DM/25/3209 Cuckfield Cottage Homes

OBJECTION

We were approached by Mr & Mrs Sewell-Rutter, owner-occupiers of The Old Clergy House located immediately West of the application site, to undertake a detailed review and assessment of the proposed scheme DM/25/3209. Supported by our professional findings they are here objecting to the proposed scheme.

Outbound Views from Flat 2A (from the new rear extension)

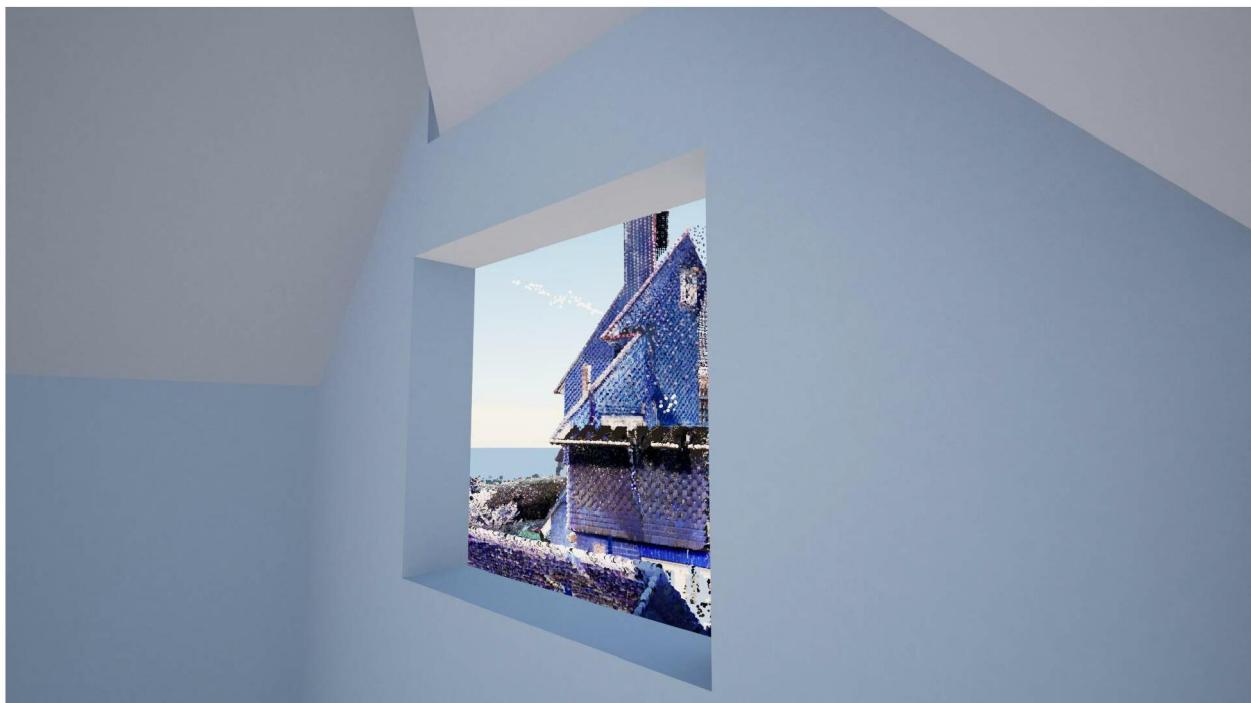
Outbound Views from Flat 3A (from the new rear extension)

Elevated overlooking of eastern morning terrace and oblique views into bay windowed habitable rooms (13.5m window-window)

Elevated views directly onto main terrace and garden

Oblique elevated views into rear garden

Outbound Views from Flat 1A (from the new rear extension)

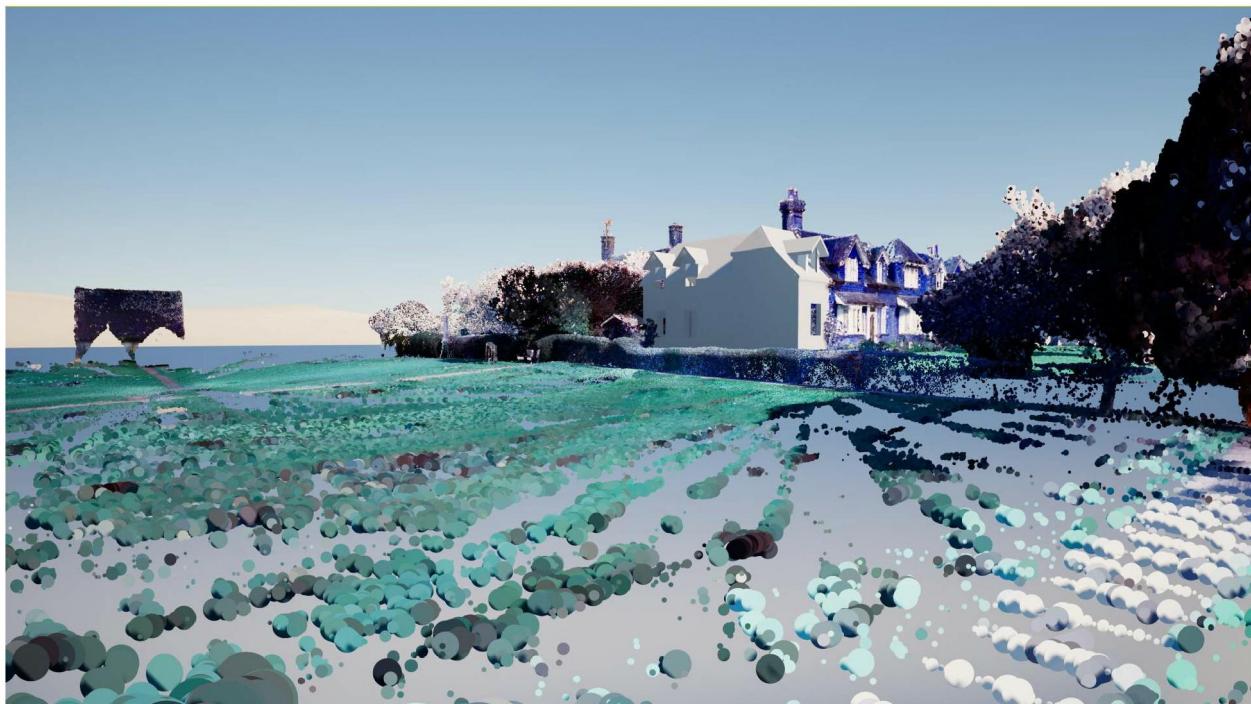
Outbound views over driveway to public realm

Oblique views into back garden

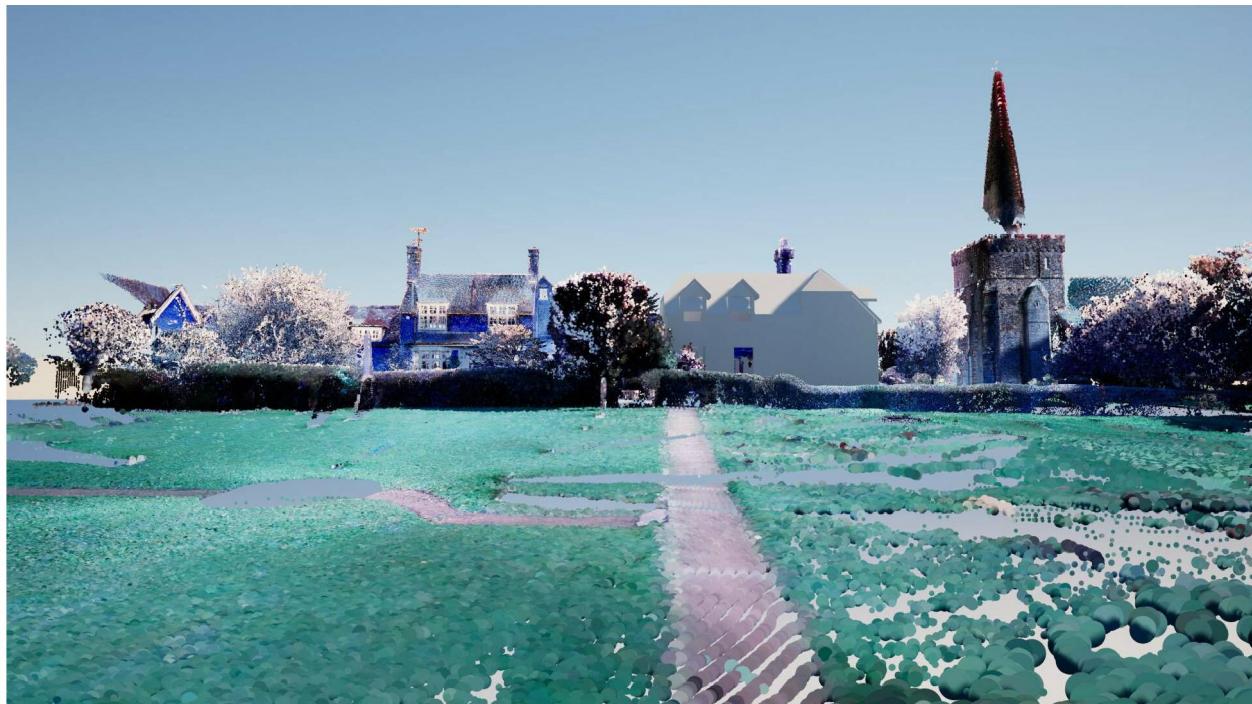
The application includes 'as existing' and 'as proposed' sketch 3D impressions. Whilst we appreciate that they have been positioned from the North West to show the first floor rear extensions as well as the two storey extension masked with vegetation, no representation of the view from the South, South East or South West has been offered, which would show the proposal in the context of the open churchyard, occupying the prominent corner immediately adjacent the church.

View North West from the churchyard illustrating the low boundary treatment and unforgiving, largely blank South elevation of the proposal

Looking due North from the churchyard

Looking North East, view towards the church obscured by proposal
